**RS-RFQ-005-2025
 Request for Quotation
 NL Fire Station Showers**

**Addendum No. 1
 (to the Request for Quotation Document)**

RS-RFQ-005-2025
Addendum 01

Figure 1 - Photo of Typical Jail Cell

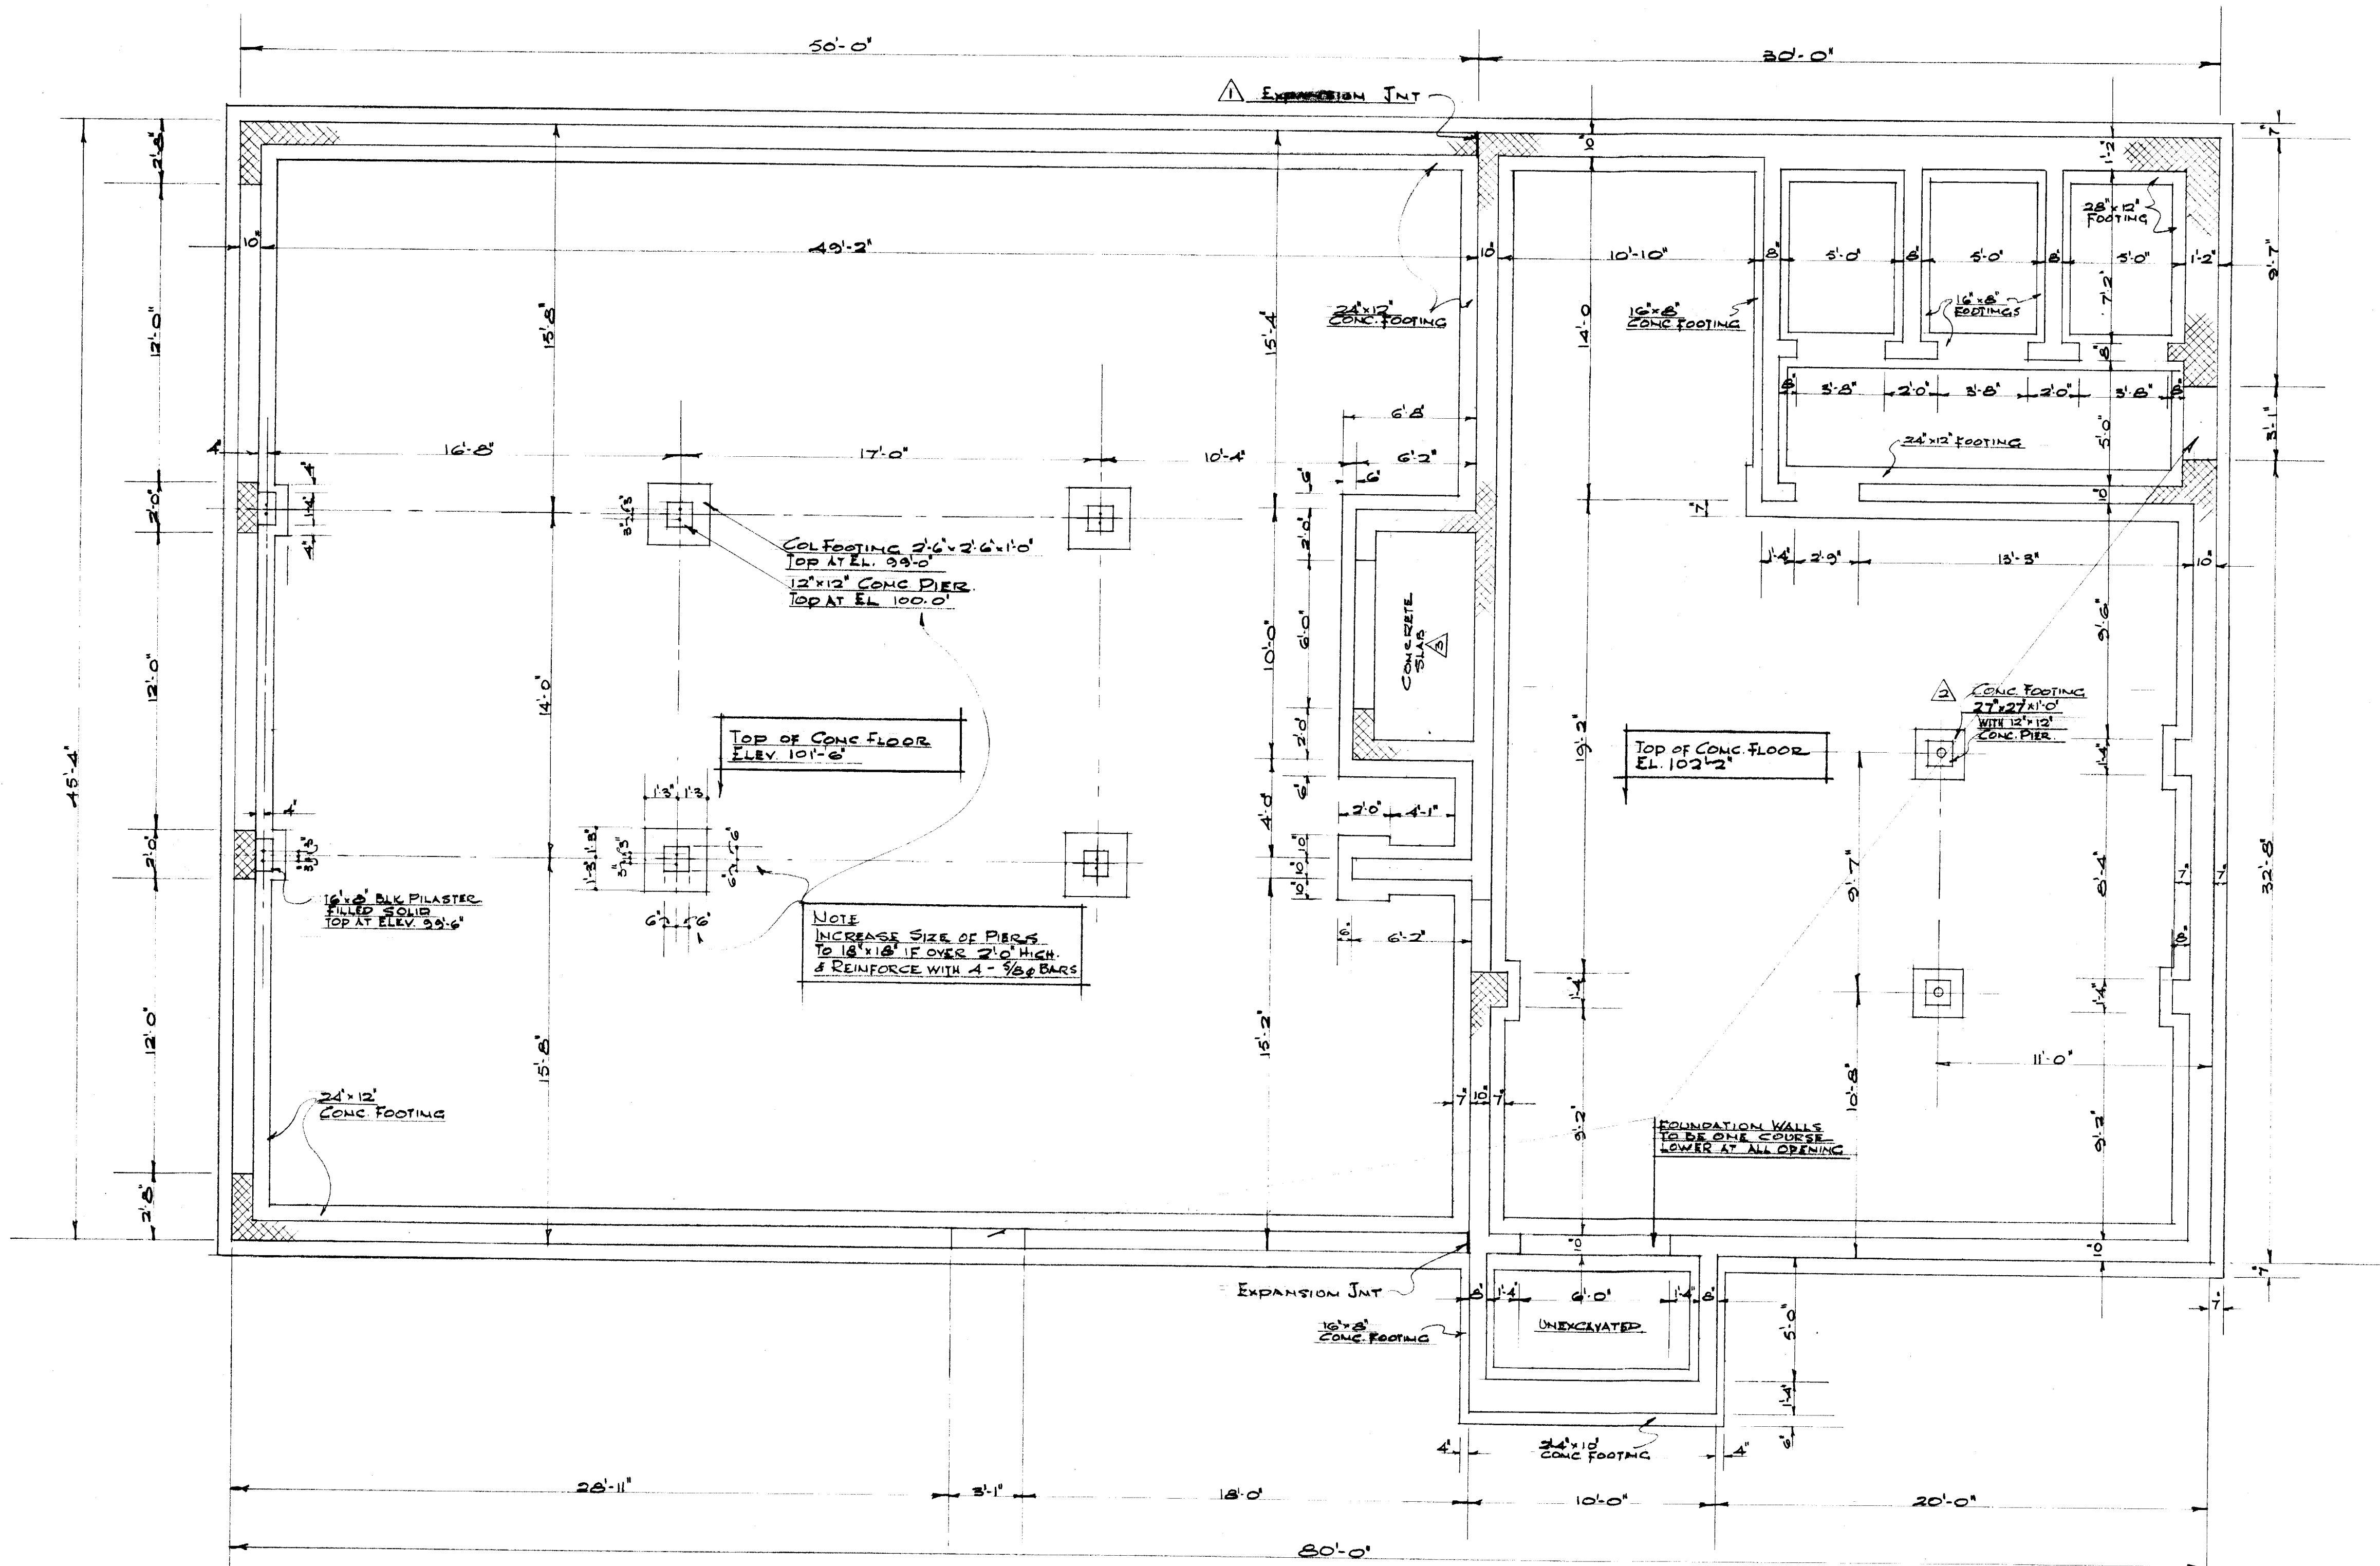
a)	Access to plumbing within ceiling – A question about access to the plumbing between the first floor and second floor was brought up at the meeting. Further, concerns were raised that the ceiling on the first floor under the proposed locations of the two new showers may contain asbestos.
-----------	---

<p>The City has removed a sample of the material and sent it for testing to confirm the presence of asbestos. On review of available plans for the building, references to asbestos panel in the ceiling of the jail cell area were noted.</p> <p>If asbestos is confirmed in the ceiling panels of the jail cell area a new detail will be provided in a subsequent addendum. Bidders will be asked to remove the asbestos paneling and replace with an alternative ceiling panel material.</p>
<p>b)</p>	<p>Plumbing – Questions on plumbing routing and location of vents were also received at the site meeting. The original drawings for the building have been included as Appendix 02 to this Addendum which includes details on the plumbing as well as information on the cavity between the first and second floor where plumbing is run.</p>
<p>c)</p>	<p>Access – City officials noted that one fire truck would be removed from the Fire Hall for the duration of construction to allow for a work area for the winning bidder.</p>
